REVIEW OF THE CRYOGENIC BY-PASS FOR THE LHC DS COLLIMATORS

**ELECTRICAL CIRCUIT MODIFICATION,
INCLUDING OPERATIONAL
CONSIDERATIONS**

PRESENTED BY A. SIEMKO

PROTECTION ISSUE: ELECTRO-MAGNETIC COUPLING BETWEEN BUS-BARS

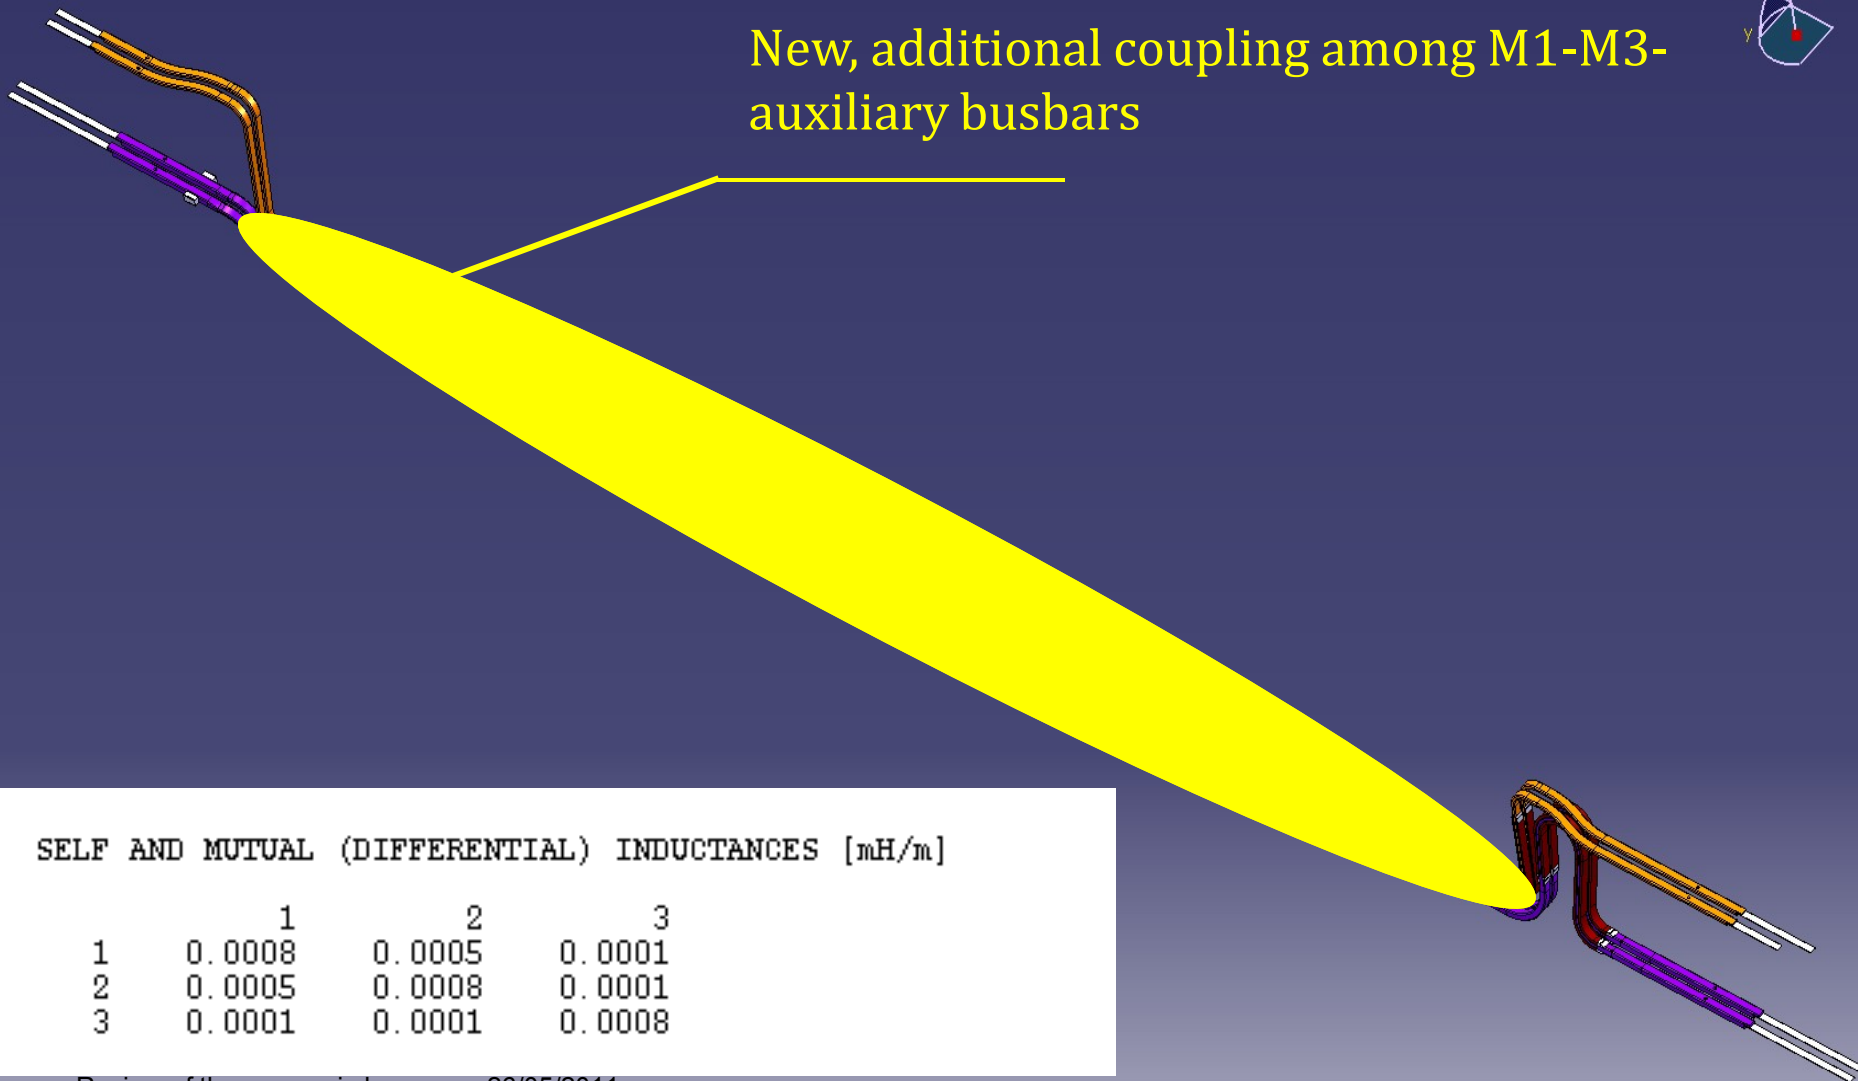
New, additional coupling among M1-M3-auxiliary busbars

- **Cross-talk between superconducting circuits due to inductive and capacitive coupling**
 - Only an issue during fast current discharges with some 100 As⁻¹
 - Estimates indicate that over the concerned bus-bar length ca 180 μ V apparent voltage may be induced
 - nQPS nominal threshold for splice protection will be $U_{TH} = 300 \mu$ V with 10 seconds reaction time permitted
- **Two cases to be considered:**
 - M1 versus M3
 - and spools versus M1/M3

- **Case1: M1 and M3**
 - Potential trigger of nQPS (splice protection only) systems during fast discharges
 - Concerned systems do not activate quench heaters
 - Global circuit protection will initiate fast circuit discharge if any of the main circuits is triggering -> no issue for LHC exploitation
- **Case 2: M1/M3 and spools**
 - Between M1/M3 and spools
 - A trip of a spool piece circuit must not cause a fast discharge of one of the main circuits
 - Spool piece bus-bars are currently routed close to M1 and M2
 - So far no major problems observed but no guarantee for the new case (needs to be verified experimentally)
- **Eventual coupling effects could be mitigated /ruled out by additional instrumentation**

PROTECTION ISSUE: REVISED PROTECTION SCHEME

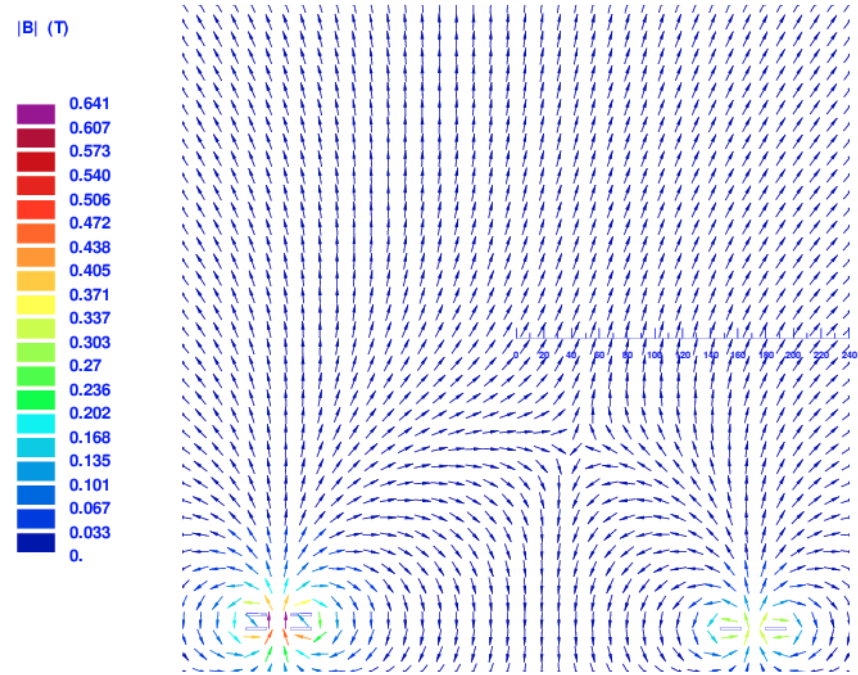
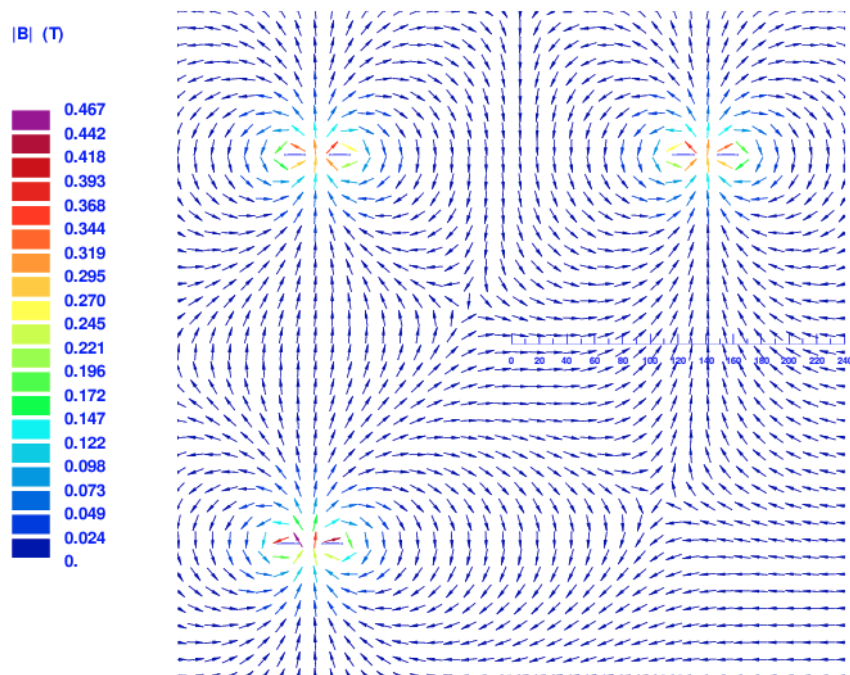
- **In principle the protection of the new bus-bar segments and splices could be assured by the existing protection units but ...**
- Neighboring QPS locations have to be modified introducing a singularity in the QPS protection scheme
 - By this the protection of the original segment will be weakened
- No possibility other than raising thresholds to overcome problems related to cross-talk or other EMC related perturbations (e.g. collimator operation ...)
 - Change of thresholds not recommended for LHC running with nominal powering parameters
- No separate protection or diagnostics for the newly installed components
 - New type of cryostat etc. -> enhanced diagnostic capabilities desired

- **Implement dedicated protection module allowing decoupling and supervision of the busbars and interconnections routed through the new cryostats**
- **Add two redundant twisted pairs per interconnection in lines M1, M2 and M3**
- 12 x 2 twisted pairs per QTC → design is critical for the overall electrical integrity and protection efficiency
 - One or two IFS boxes required depending on integration
- **Additional taps can be used as well for the quality assurance and electrical tests @ warm**
- **No additional taps required for spool piece bus-bars protection**
- Nevertheless very useful for diagnostics -> implementation to be considered
